STAFF ANALYSIS

Case No.: SLUP-22-1245321 **Agenda #:** D6

Request: Special Land Use Permit to allow a drive-through car wash in a C-1 (Local Commercial) District.

CCW Site Plan.pdf

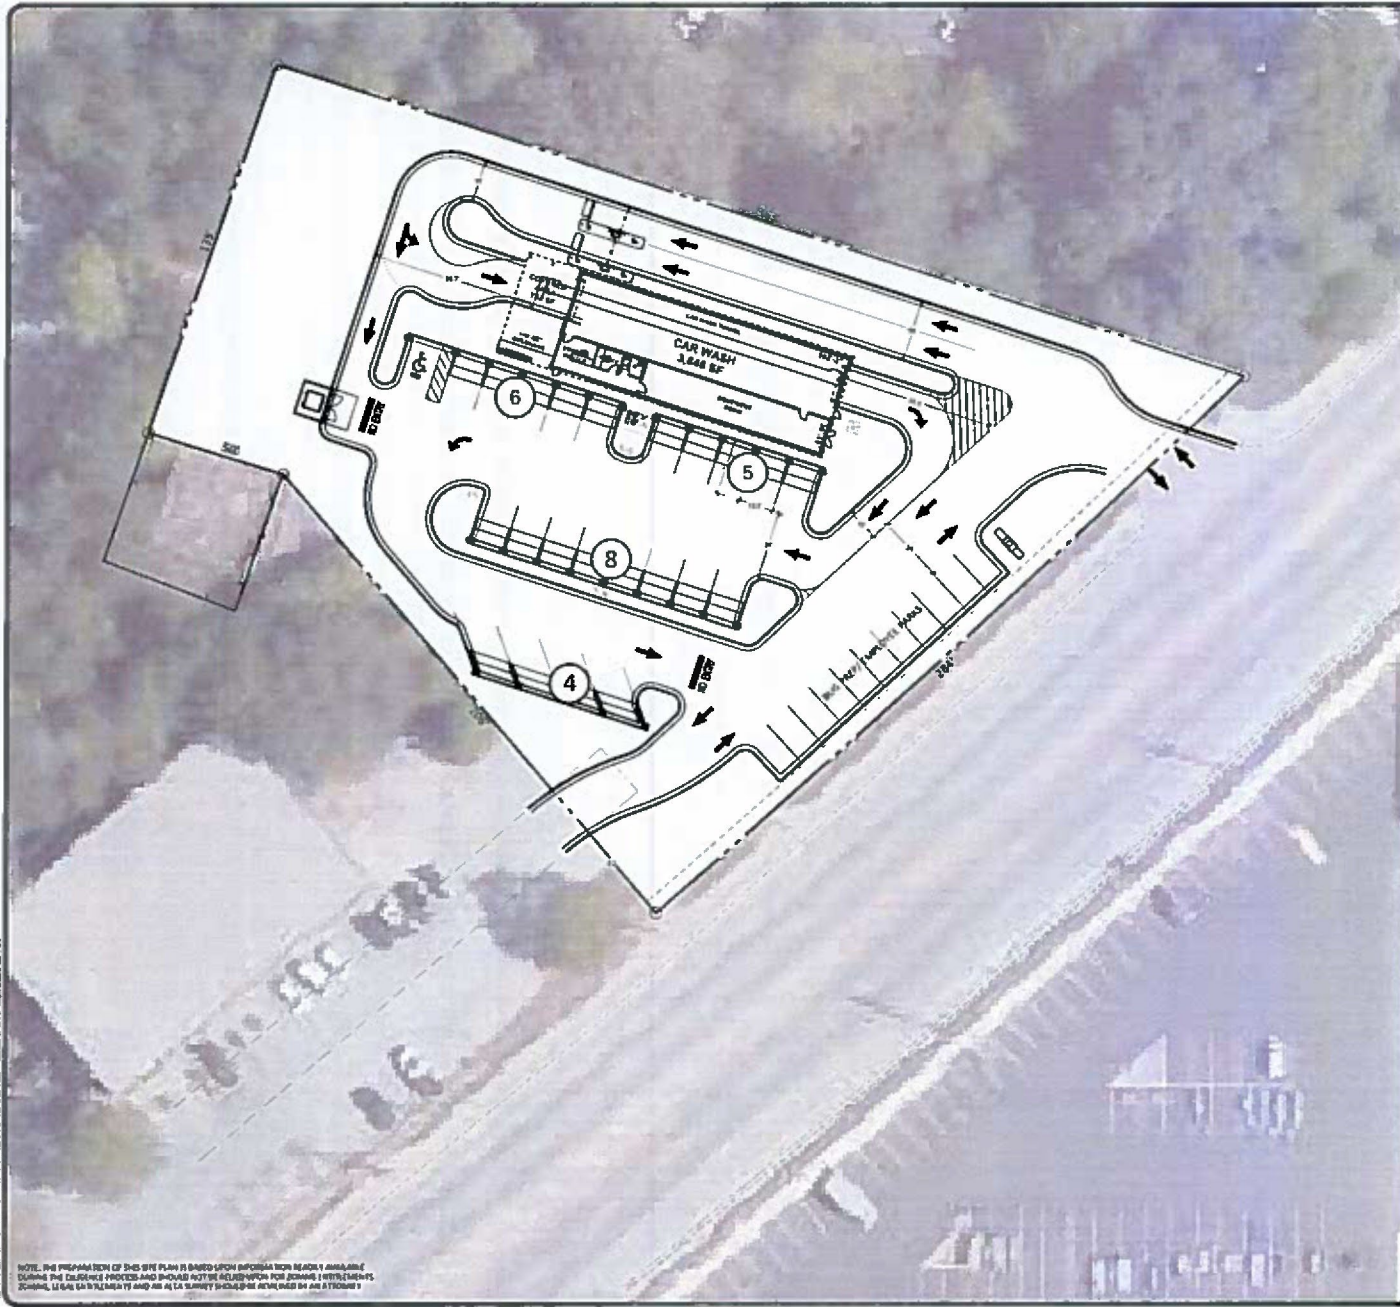
| C-1 STANDARD | | REQUIREMENT | PROVIDED/PROPOSED | COMPLIANCE |
|--|---------------|---|---|--|
| MIN. TRANSITIONAL BUFFER | | 50 ft. w/ 6-ft. screening fence along northeast property line. | Drive-through lanes are located in the transitional buffer. | No - Site must comply or a variance will be necessary. |

The proposed plan does not comply with the transitional buffer and front yard setback of the C-1 District.

The applicant does not meet the required 50-foot buffer, and a variance will be necessary. The site plan indicates a 10-foot landscape strip along the northeast property line. The applicant has agreed with adjoining residential property owners to replace a solid wooden fence that screens their properties from the subject property.
